LUXCON PROPOSAL - LANDSCAPE CONCEPT PLAN

103 Beach Street Port Melbourne

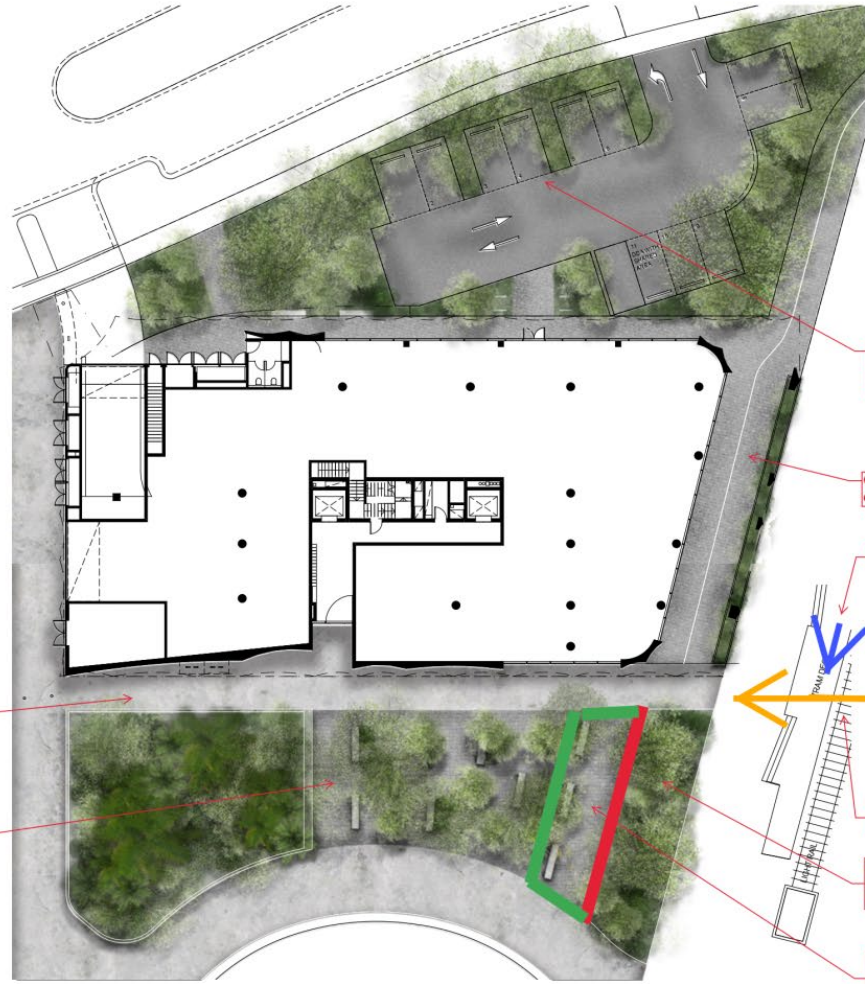
All new / reinstated public realm paving (apart from seating area) to match existing Waterfront Place treatment

Mismatched stone paving to seating area only, no loose gravel.

Suggest reconfiguring to 2 groups of 3 parking bays, with single landscape buffer. This should reduce overall amount of hard paving by reducing car parking aisle length by approximate 1.5m.

Cobbled paving has create accessibility problems for many people. Prefer concrete paving to match existing Waterfront Plaza treatment.

This area to east of red line is outside of scope for new planting as it will be incorporated into future Tram Terminus Redevelopment works. As an interim measure, install concrete paving to match existing plaza pattern.

Move proposed planter bed west (to other side of red line). This will reduce at least one row of seating but will still provide plenty of space for a generous, well-defined seating area.
